NSW Planning Portal Application – Request for Additional Information

Council Application Number: DA21/0812
Property Address: 931 Cudgera Creek Road and
1023 Cudgera Creek Road, CUDGERA CREEK 2484

Description: Integrated Development - concept application for an agricultural food hub comprising of 19 rural industry sheds, associated earth works and internal site roads (NRPP)

Figure 1: Proposed New Access Concept (Source: Mecone)

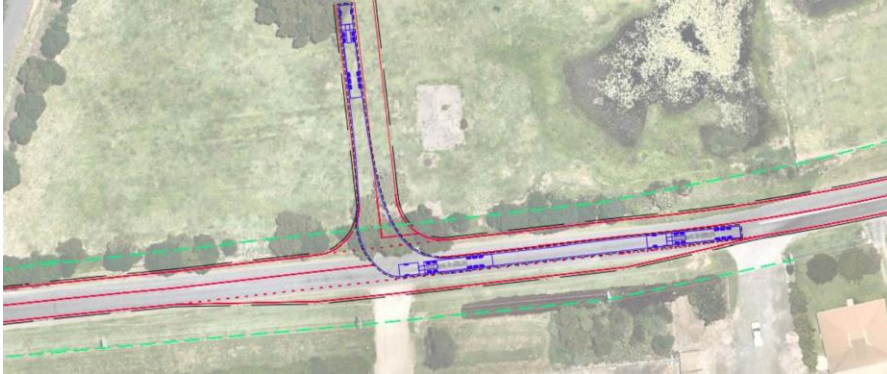
From a brief assessment of the new access concept the following issues have been identified:

- a. The proposed access from Cudgera Creek Road appears to impact the Ecological Corridor 30m wide that traverses the Cudgera Creek. The extent of the Ecological Corridor is shown in Figure 2 below.

- b. Concerns regarding development within the ecological corridor were raised during the Pre-DA advice provided to the applicant which has been included within their SEE (Sep 2021). In particular, the SEE states:

The proposed new access concept from Cudgera Creek Road poses concerns regarding the ecological corridor which requires a 30m buffer zone to each side of the creek. Adverse impacts to the ecological corridor due to the location of an access point is not supported in this case as alternative access options are available which do not impact the ecological corridor. More information is provided in the biodiversity comments in Section 7 below.
